Hop Lun Apparels Ltd. (9670)

22.MARCH.2014

Identified Priority 1 Concerns

Structural drawings do not show beam cantilever reinforcement

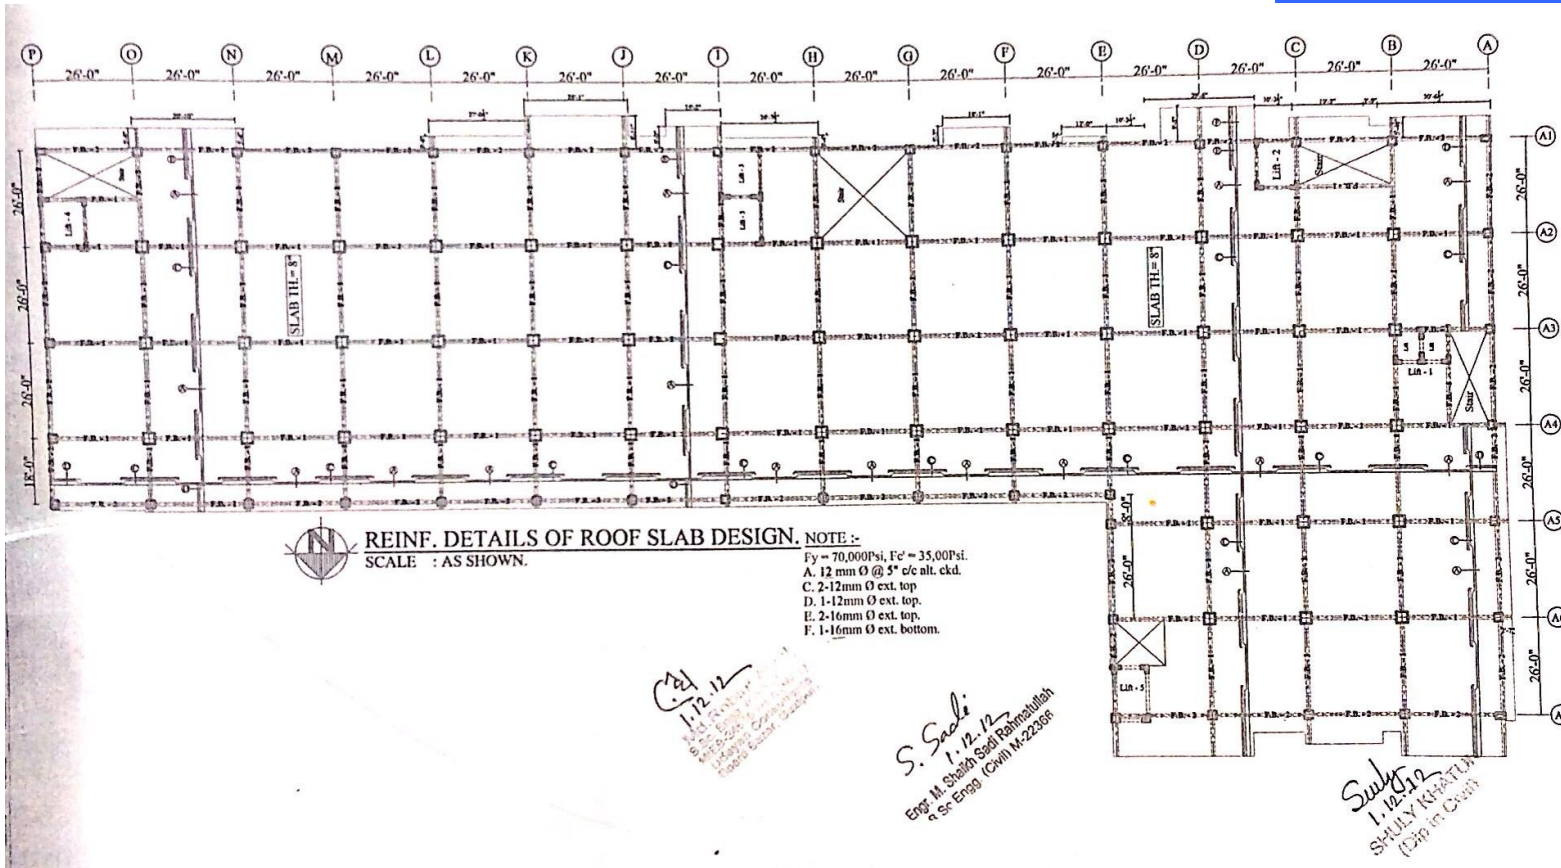
Structural drawings were, relatively speaking, very well done. However, portions of the slab were observed to be cantilevered past the column grid while no cantilever beam reinforcing details were shown. It was indicated by the factory engineer that negative moment reinforcement over the outer most column was simply extended to the end of the cantilever.

ITEM 1: (Priority 2) Typical floor beams cantilever outside of the column grid at various slab jog locations shown on the slab plans. However, floor beam plans do not indicate reinforcement that should be provided in the cantilevered portions of the beam. The factory engineer has indicated that negative moment reinforcement specified over beam supports has been placed continuously to the end of the cantilevers.

Item No.	Observation	Recommended Action Plan	Recommended Timeline
1	Typical floor beams cantilever outside of the column grid at various slab jog locations shown on the slab plans. However, floor beam plans do not indicate reinforcement that should be provided in the cantilevered portions of the beam. The factory engineer has indicated that negative moment reinforcement specified over beam supports has been placed continuously to the end of the cantilevers.	Remove any storage from cantilevered portions of floor slabs	Immediate – Now
2	Typical floor beams cantilever outside of the column grid at various slab jog locations shown on the slab plans. However, floor beam plans do not indicate reinforcement that should be provided in the cantilevered portions of the beam. The factory engineer has indicated that negative moment reinforcement specified over beam supports has been placed continuously to the end of the cantilevers.	Udayan Consultants to verify as built cantilever adequacy and amend structural drawings with cantilever reinforcing details.	6-weeks
